Access Compliance Report

Public Rights-of-Way

(Curb Ramps)

Intersection ID: 15217	Main Street: ALBEMARLE_RD	Cross Street: WINTERHAVEN_DR	Location: NE
ADA ID: 92B6B138E1B5	Ramp Type: PerpDiag	Initial Pass/Fail: Fail	Overall Compliance: No
Codes/Mitigation Info/Possible Solution		Field Measurements/Component Compliance

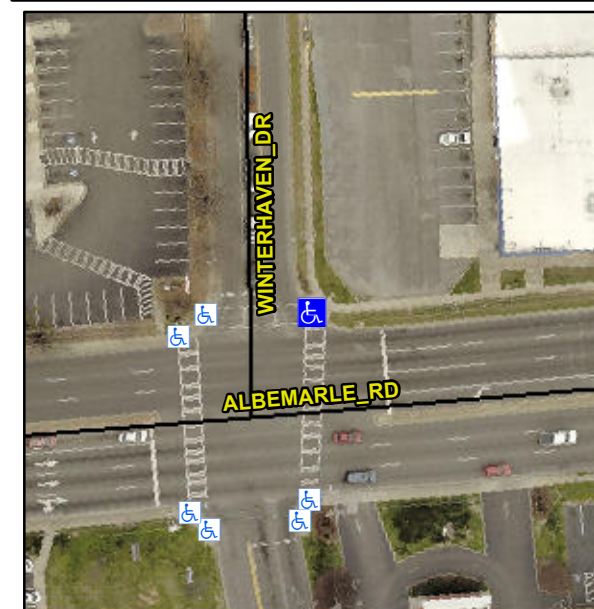
Not Found, R304.2.2

Compliance	Description	Data	Compliance	Description	Data
N/A	Ramp Length (in)	60.0	No	Ramp Slope (%)	8.6
Yes	Ramp Width (in)	52.0	Yes	Ramp XSlope (%)	2.2
N/A	Flare Type LT	N/A	N/A	Flare Type RT	N/A
N/A	Flare Slope LT (%)	N/A	N/A	Flare Slope RT (%)	N/A
N/A	Flare Traversable LT?	N/A	N/A	Flare Traversable RT?	N/A
N/A	Landing Length (in)	N/A	N/A	DWS Provided?	N/A
N/A	Landing Width (in)	N/A	N/A	DWS Contrast?	N/A
N/A	Landing Slope (%)	N/A	N/A	DWS Length (in)	N/A
N/A	Landing X Slope (%)	N/A	N/A	DWS Full Width?	N/A
N/A	Landing Curb? (Y/N)	N/A	N/A	DWS Offset (in)	N/A
N/A	Shared Landing?	N/A			
N/A	Gutter Ponding?	N/A	N/A	Gutter Slope (%)	N/A
N/A	Gutter Lip Ht (in)	N/A	N/A	Gutter X Slope (%)	N/A
N/A	Painted X Walk1?	Yes	N/A	Painted X Walk2?	Yes
	X Walk 1 Direction	To E		X Walk 2 Direction	To S
N/A	X Walk 1 Width (in)	112.0	N/A	X Walk 2 Width (in)	108.0
	X Walk 1 Slope (%)	3.3		X Walk 2 Slope (%)	1.4
	X Walk 1 X Slope (%)	4.2		X Walk 2 X Slope (%)	0.8

Remove & Replace Curb Ramp With Two New Directional Ramps or Equivalent.
